ADDENDUM NO. 1

**ADDISON CIRCLE
PHASE I
PUBLIC INFRASTRUCTURE**

January 17, 1996

PRE-CONSTRUCTION CONFERENCE MEETING MINUTES

UPGRADE TREE GRATE
5 FOOT SQ OT-T24

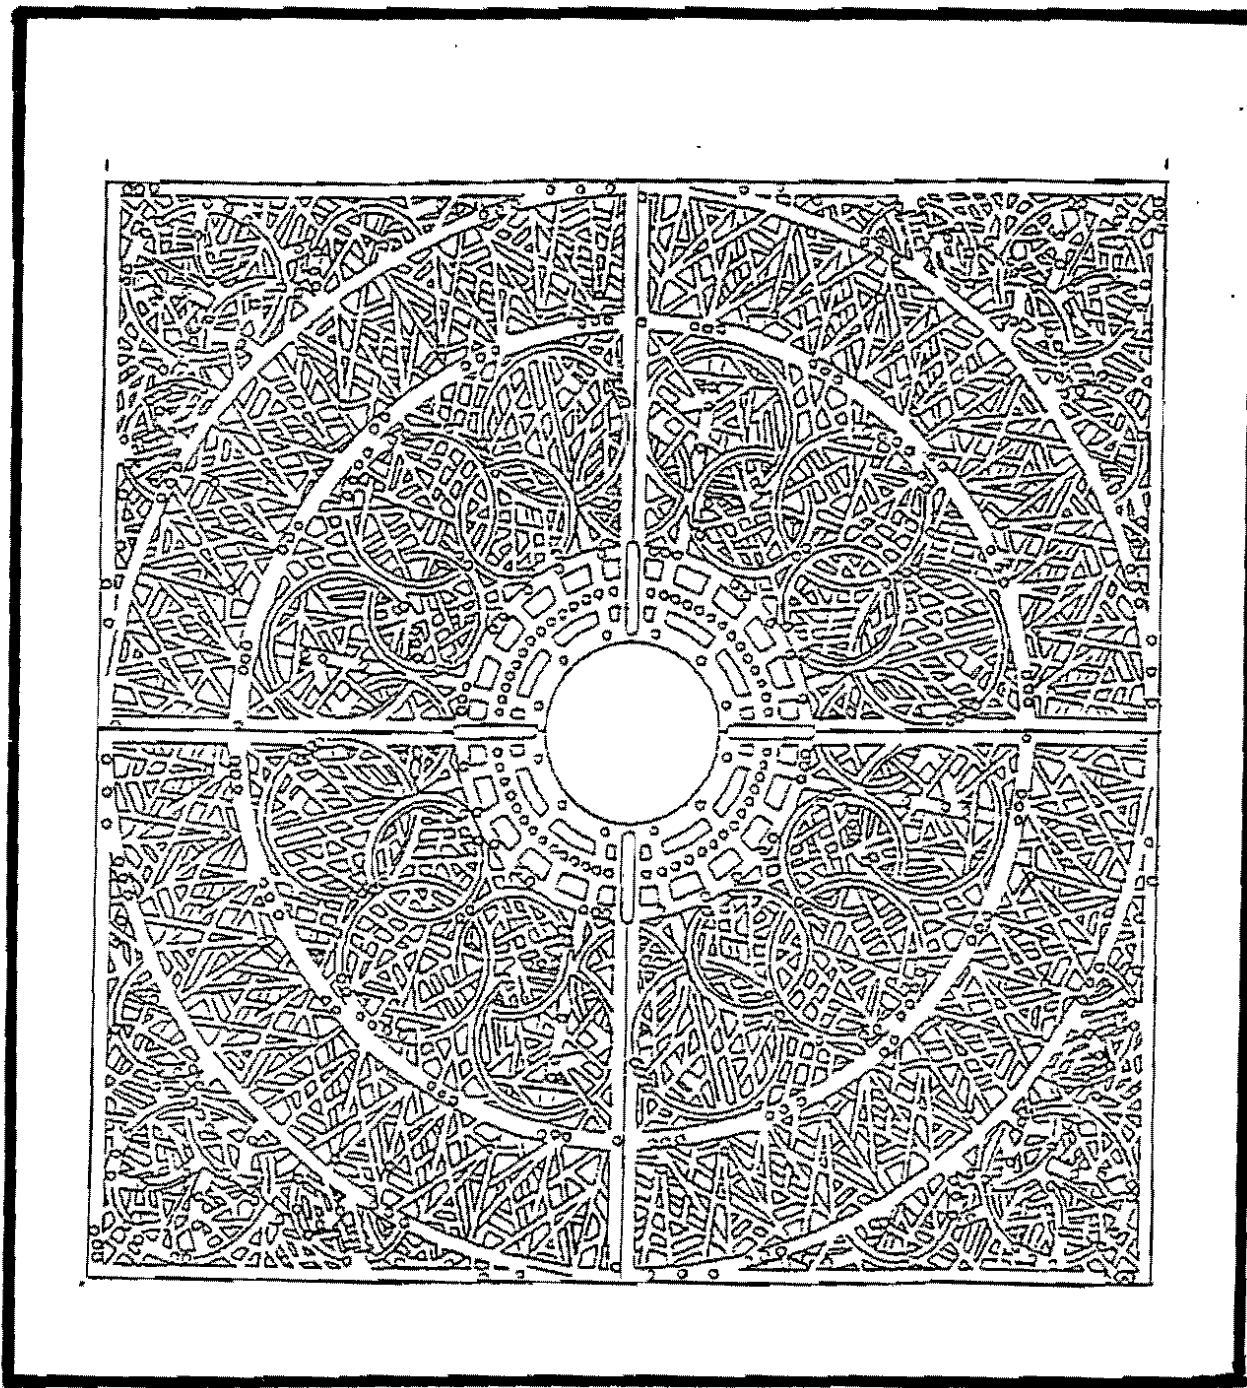
Item 901 - Upgraded Tree Grate

The specified upgraded tree grate shall be equal to Urban Accessories 5 foot SQ OT-T24, unpainted, per the attached catalog cut sheet.
